UNITED STATES PATENT AND TRADEMARK OFFICE

APPLICATION NO.	FILING DATE	FIRST NAMED INVENTOR	ATTORNEY DOCKET NO.	CONFIRMATION NO.
10/051,327	01/22/2002	Mary L. Bussler	0981/1	2715

Office Action Summary

DETAILED ACTION

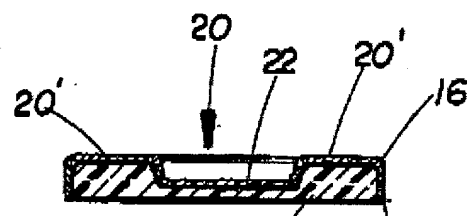
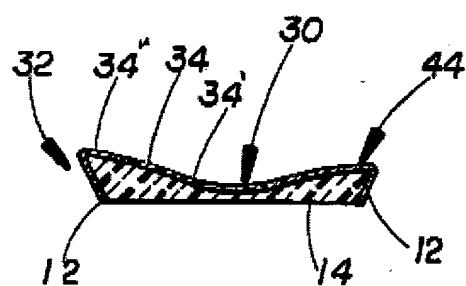
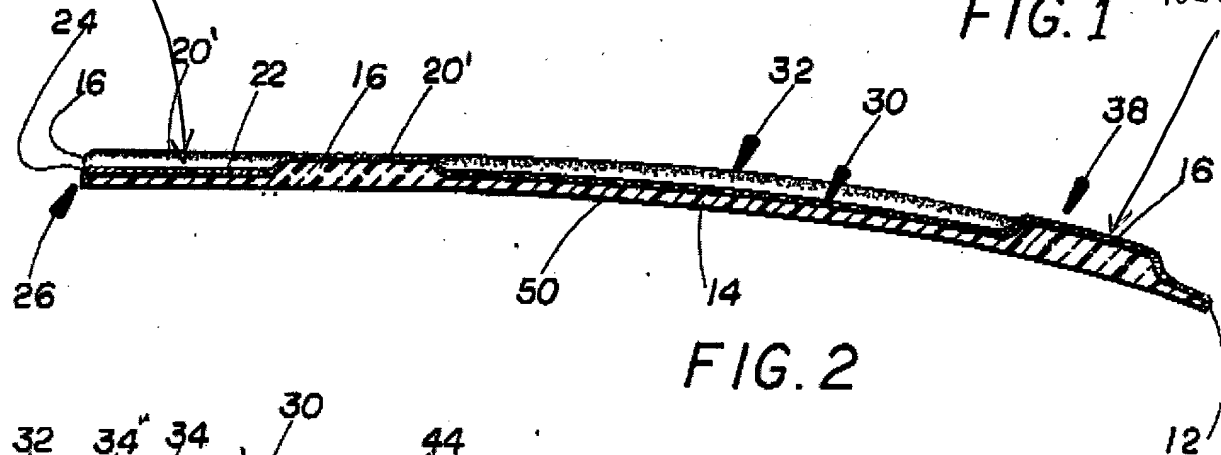
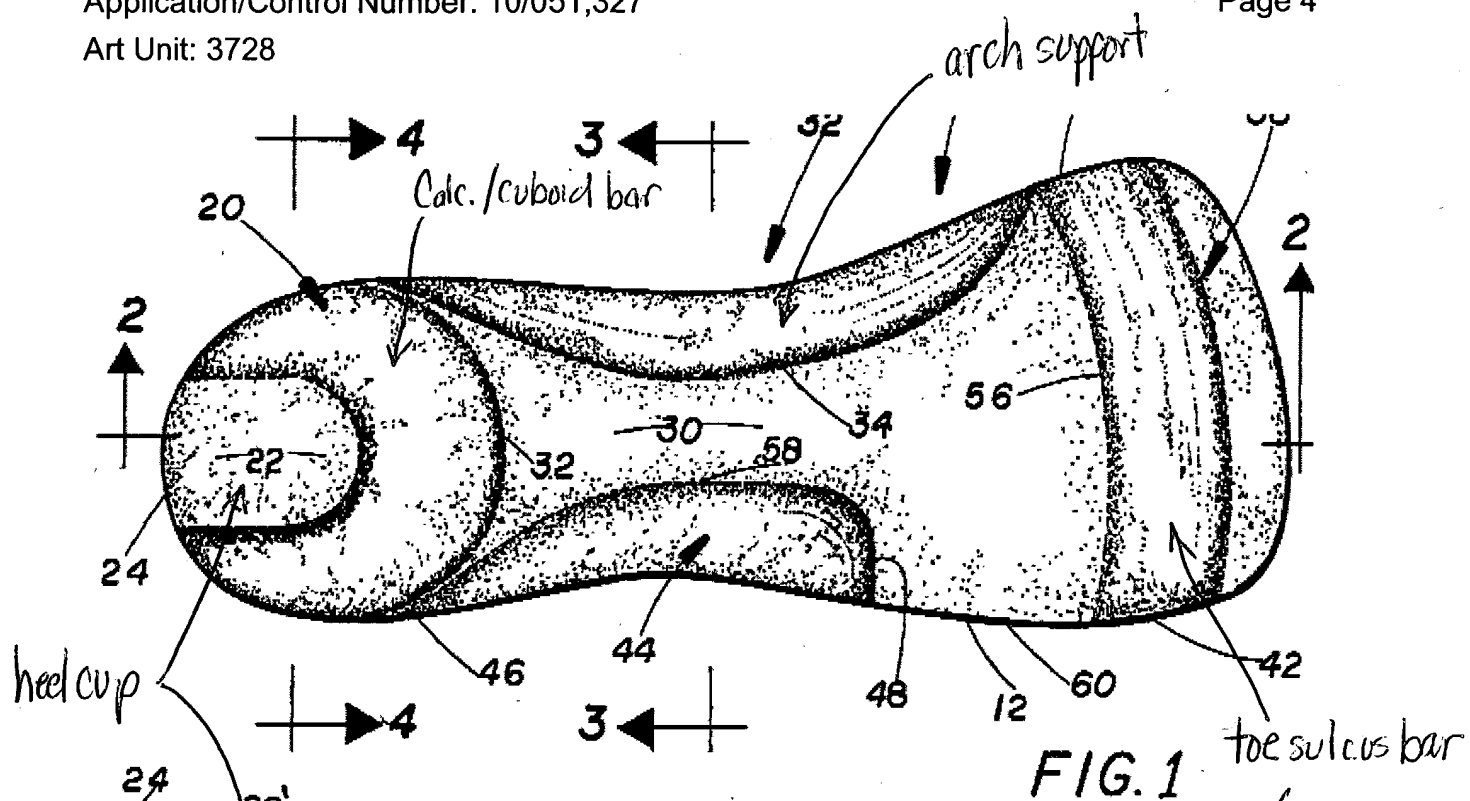
6. Claims 1 and 6-9 are rejected under 35 U.S.C. 102(b) as anticipated by or, in the alternative, under 35 U.S.C. 103(a) as obvious over US 4955148 (Padilla).

Padilla teaches the combination of a high-heeled shoe (see col. 1, lines 12-25) and a footbed (foot support assembly) as claimed, see the marked-up figures below. The foot support provides proper fitting within a give shoe style, see col. 2, lines 5+.

Padilla doesn't show the high-heeled shoe (otherwise known as pump shoes) but it is well known in the art for them to have an upper, a toe box and a heel having a height of at least 1 inch, and some being more than 3 inches. To the extent that Padilla doesn't teach a high-heeled shoe as claimed, the examiner takes official notice that high-heeled shoes having a toe box and heels of such height are well known and conventional in the art. Therefore, it would have been obvious to provide the shoe of Padilla with a high-heeled shoe, to provide proper support and balance to high-heeled shoes.
